**Re: Part VIII Planning Report for the construction of 43 residential units at Sycamore Avenue,
Rathbane, Limerick**

**PLANNING REPORT IN ACCORDANCE WITH
SECTION 179 3(a) OF THE PLANNING & DEVELOPMENT
ACT 2000 (as amended)**

At: Sycamore Avenue, Rathbane, Limerick

Planning Reference No. 18/8007

Site Layout:

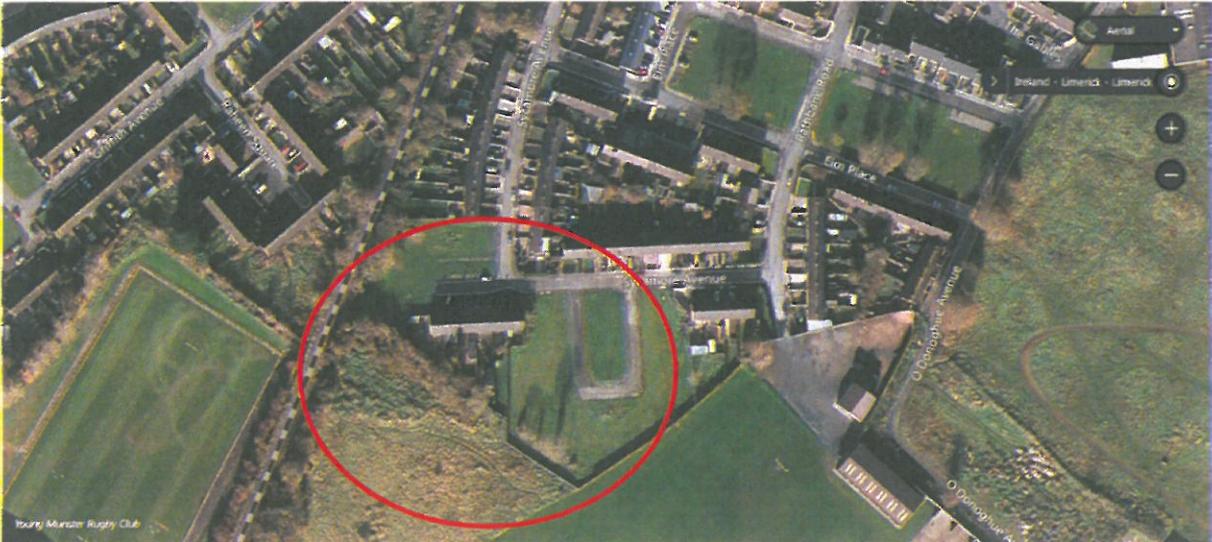
1. Traffic impact (volumes, safety, access, parking, infrastructural condition, assessment),
2. Removal / relocation of existing green areas,
3. Impacts of three-storey development adjoining existing houses,
4. Unit quantity / mix,
5. Devaluation of existing privately owned property,
6. Social atmosphere (interim construction nuisance & increased anti-social behaviour).

1. Removal / relocation of existing green area,
2. Traffic impact (increased volumes, safety),
3. Contextual appropriateness of three-storey development,
4. Socio-economic impacts,

1. Traffic considerations – refer to Submission Response Appendix A – Response 1.0
2. Open space provision – refer to Submission Response Appendix A – Response 2.0
3. Three-storey development – refer to Submission Response Appendix A – Response 3.0
4. Unit quantity / mix – refer to Submission Response Appendix A – Response 3.0
5. Devaluation – While the Local Authority considers that the proposed development will positively contribute to the existing environment by generating a fresh new contemporary aspect to the existing residential area, development impact on property valuation is not a planning consideration for the proper and sustainable development of an area.
6. Social atmosphere – refer to Submission Response Appendix A – Response 4.0

1. Open space provision – refer to Submission Response Appendix A – Response 2.0,
2. Traffic considerations – refer to Submission Response Appendix A – Response 1.0,
3. Three-storey development – refer to Submission Response Appendix A – Response 3.0,
4. Socio-economic impacts – refer to Submission Response Appendix A – Response 4.0,
